P 28646

SEWAGE DISPOSAL SYSTEM

MARYLAND STATE DEPARTMENT OF HEALTH*

HOWARD COUNTY

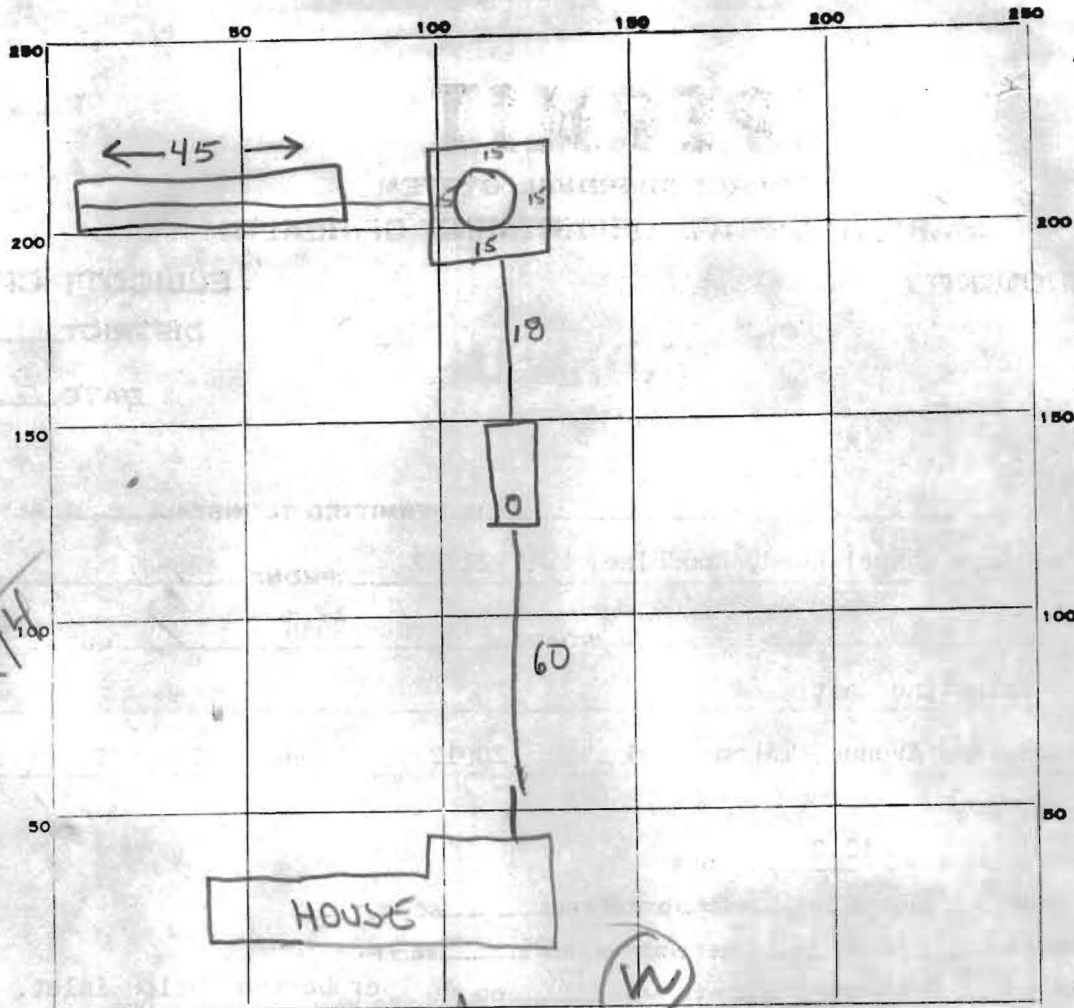
9 Aug 78 - (inlet to trench at 5') OK to add gravel to trench. Call for final when cleanouts are installed, gravel in dry well leveled, and ^{when} both house connection and 1 ft spacer in septic tank (1250) can be inspected. (GLK) 10 AUG 78 ABOVE ITEMS FINISHED RH
